Product Change Notification

110012 - 00

Change Notification #: 110012 - 00
Change Title: Intel® Server Systems SR1625UR,
SR2625UR and Intel® Server Accessory
FSRTCHSPR, PCN 110012-00, Product
Design, 2.5 HDD Carrier Design is changed
Date of Publication: May 17, 2010

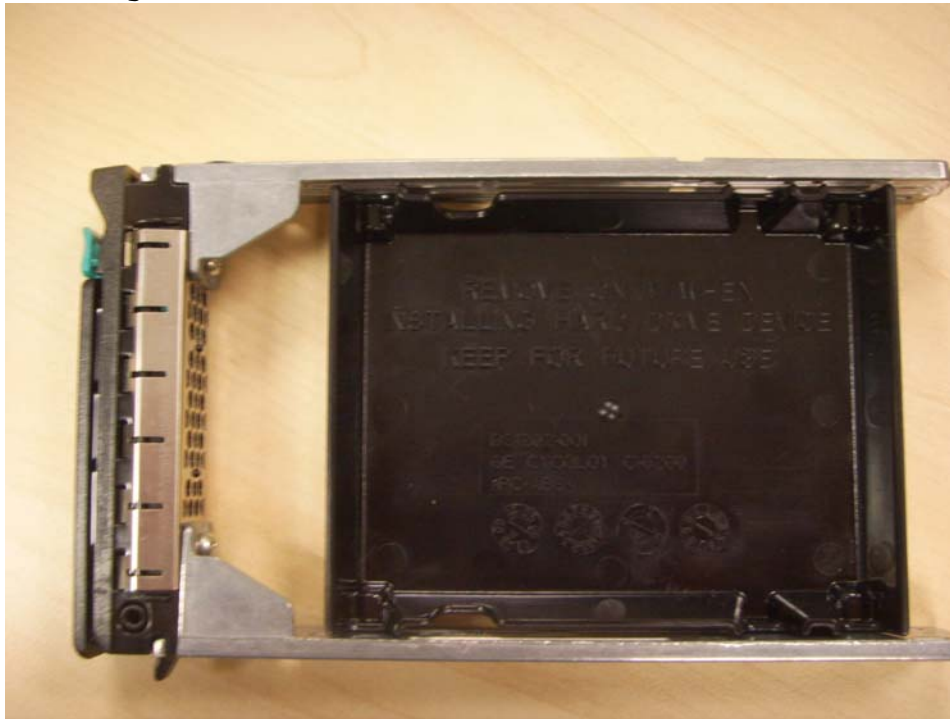
The 2.5 Inch HDD Carrier is being changed to remove the Gusset plate from both the left and right rails. Please refer to the following pictures for further detail. The modification is to allow for a wider variety of hard drives to be used with the carrier.
